**7-G-20-HZ**  
**APPLICATION FOR CERTIFICATE OF APPROPRIATENESS**

1111 Eleanor St. 37917  
 \_\_\_\_\_  
 Fourth and Gill H-1

# Staff Report - Certificate of Appropriateness Application

File Number: 7-G-20-HZ

**SIDE ELEVATION (SOUTH)**

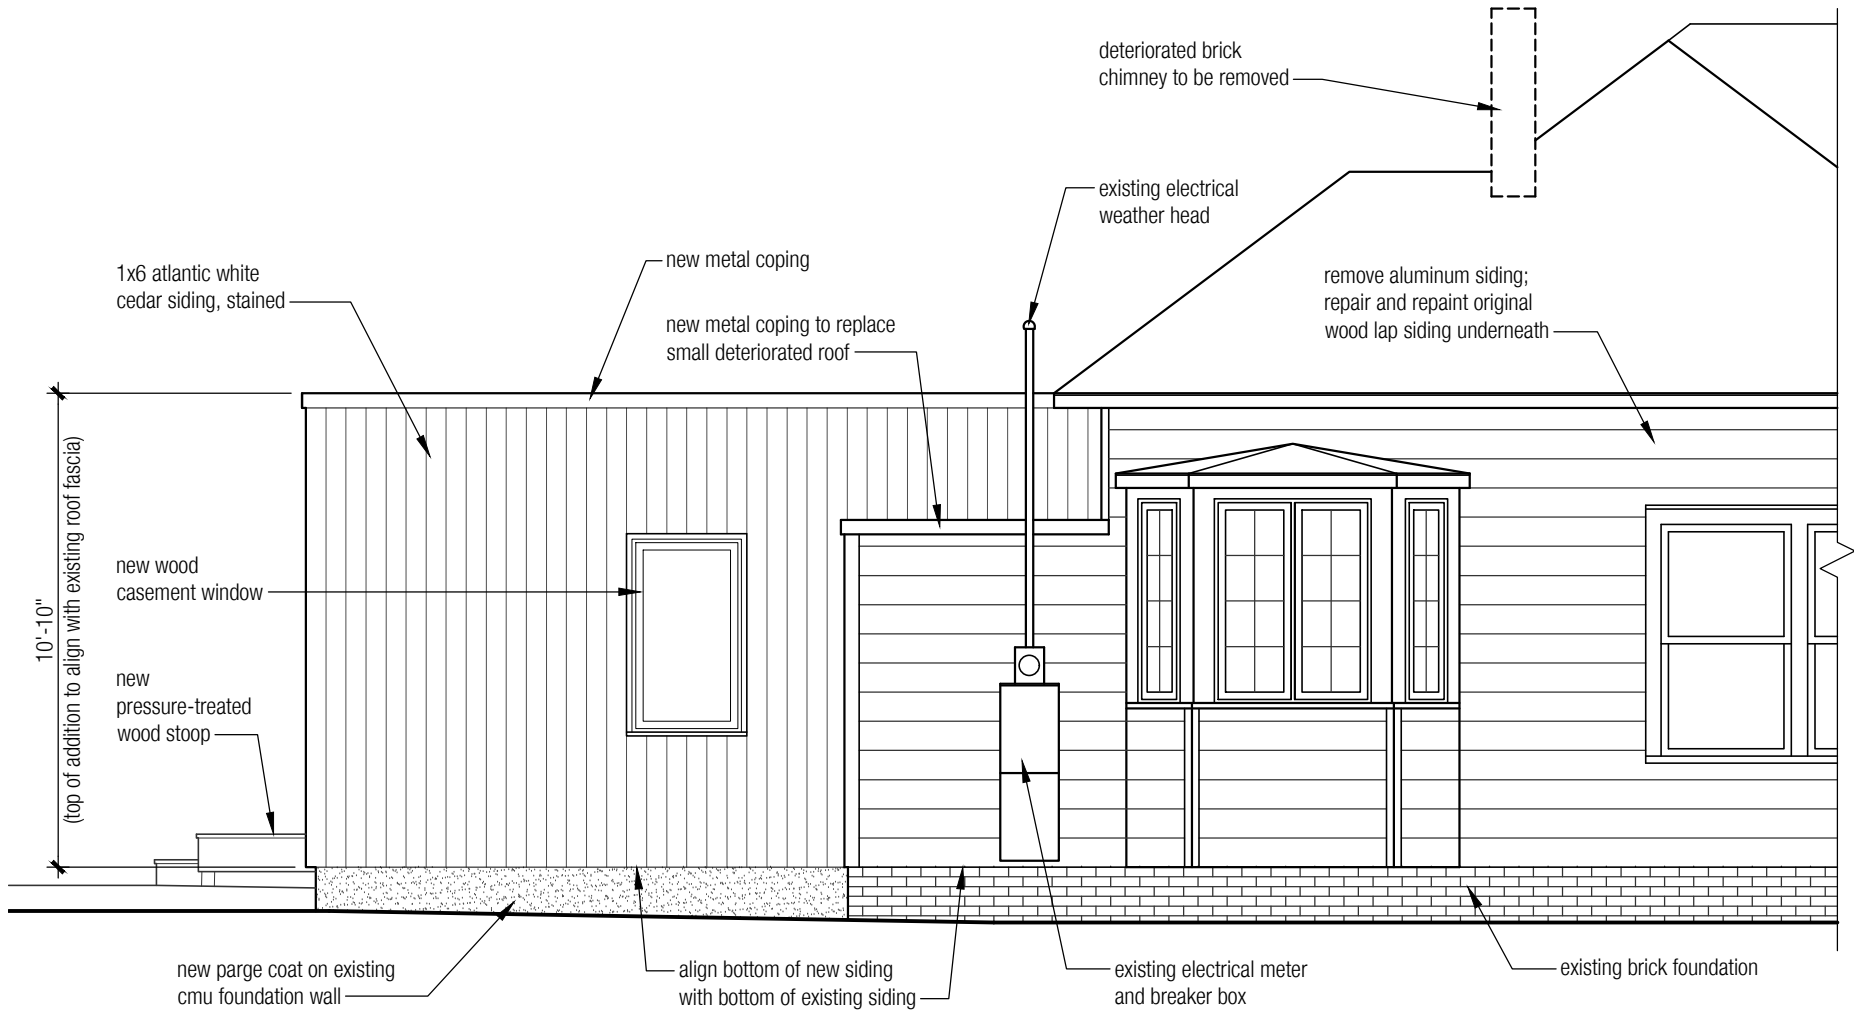
Foundation will receive new parge coat. Addition is proposed to have a flat roof with new metal coping along the roofline, and new metal coping along an existing roof on the south elevation. South (side) elevation to feature a single-light wood casement window. North (side) elevation to receive two adjoining wood casement windows. Rear (west) elevation to feature aluminum-clad sliding patio doors with cedar carriage doors on each side (hinged to swing closed over patio door), one rectangular wood awning window, and a pressure-treated wood stoop.

**REAR ELEVATION (WEST)**

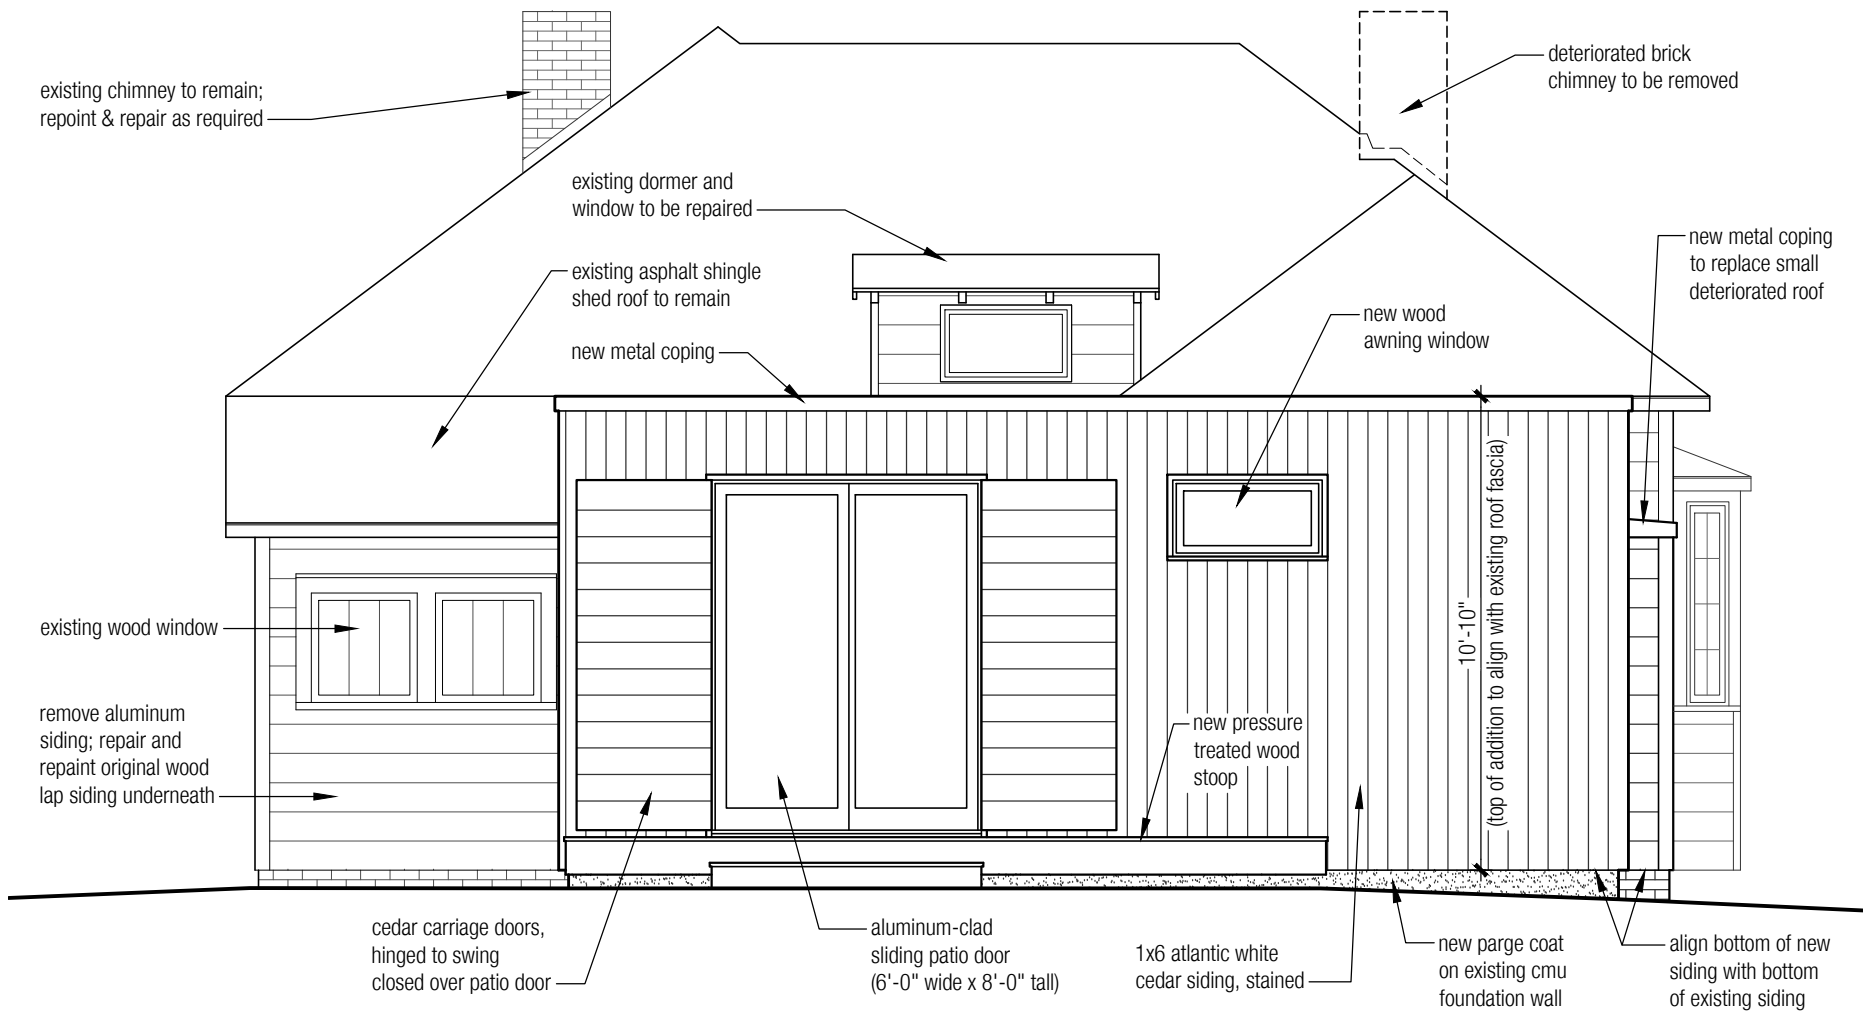
Rear addition: removal of non-historic, rear, shed-roof screened-in porch. Rear addition to be constructed on existing CMU foundation and will not expand the footprint of the existing porch. Addition will measure 24'-1" long by 12'-2" deep and be clad in 1x6 atlantic white cedar wood vertical siding, which will be stained. The addition will be 10'-10" tall, with the top of the roof aligning with the existing roof fascia.
